# IV. Remarks

Patent Application for BEARINGLESS PINION WITH CLEANING EDGES Inventor(s): Monroe et al.

Application No.: 10/004,758; Attorney Docket No.: 10541-636 Annotated Replacement Sheet Mailed July 22, 2004

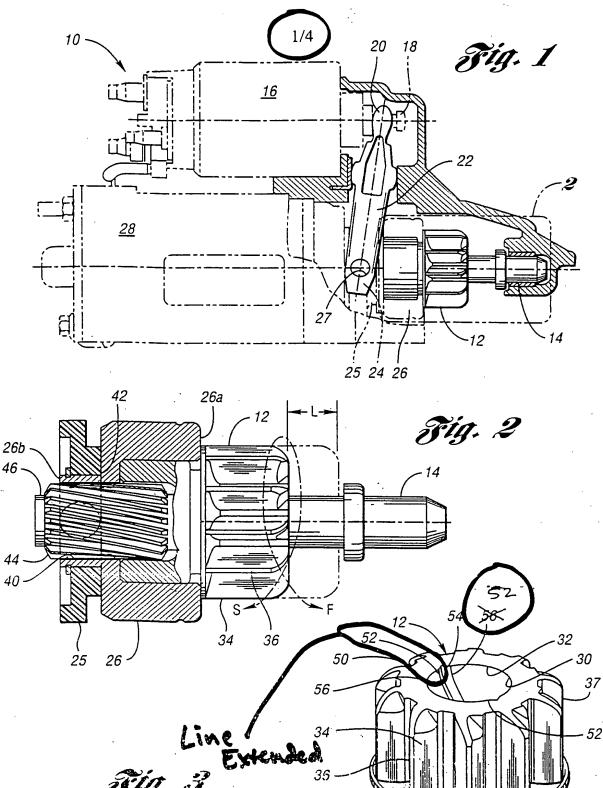
Figure 3 has been amended to replace one of the occurrences of reference numeral 56 to the reference numeral 52. Paragraph [0019] of the original Application as filed recites that the primary edge 52 is formed along the length of inner surface 32 and that the primary edge 52 forms a groove 54. Paragraph [0020] of the original Application as filed recites that the secondary edge 56 radially extends on the end face 50, and original Figure 3 in the Application as filed shows another occurrence of the reference numeral 56 properly pointing to the secondary edge 56 extending around the end face 50. Therefore, the amended reference numeral should be 52 rather than 56 and no new matter is added.

Furthermore, Figure 3 has been amended to extend the reference line of one of the occurrences of reference numeral 52 to the primary edge 52 formed along the length of inner surface 32. As discussed above, Paragraph [0019] discloses the primary edge 52 as being formed along the length of inner surface 32 and as forming a groove 54. Therefore, the amended reference line should extend to the primary edge 52 forming the groove 54 and no new matter is added.

Patent Application for BEARINGLESS PINION WITH CLEANING EDGES Inventor(s): Monroe et al. Application No.: 10/004,758; Attorney Docket No.: 10541-636 Annotated Replacement Sheet Mailed July 22, 2004

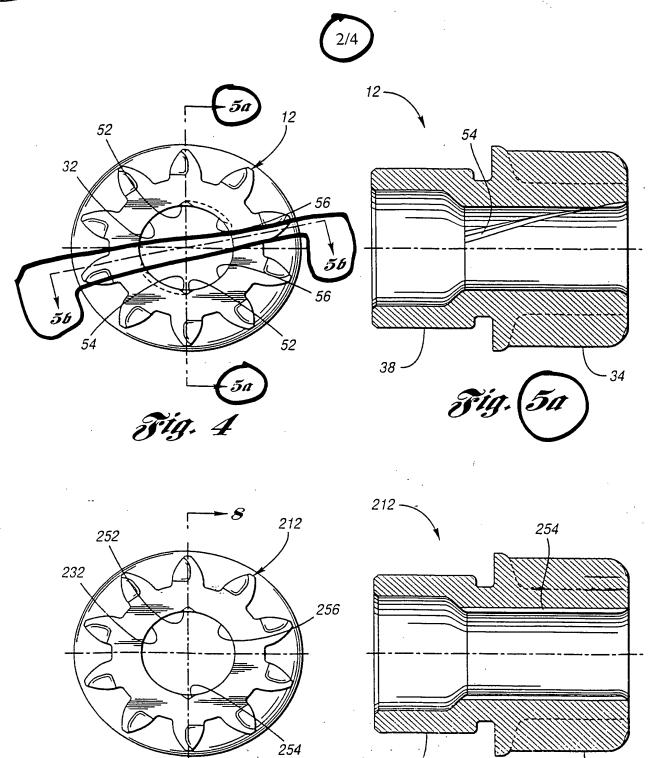
Figure 4 has been amended to renumber line 5-5 as line 5a-5a and to include an additional cross-sectional line labeled 5b-5b. As a result, Figure 5 has been renumbered as Figure 5a.

Furthermore, Figure 5b has been added as a cross-sectional view of Figure 4 taken along line 5b-5b in order to show the angle 51 of the secondary edge 56 that is defined by the inner surface 32 and the end face 50 of the pinion 12. Figures 3-5, 7, and 8 collectively show that the inner surface 32
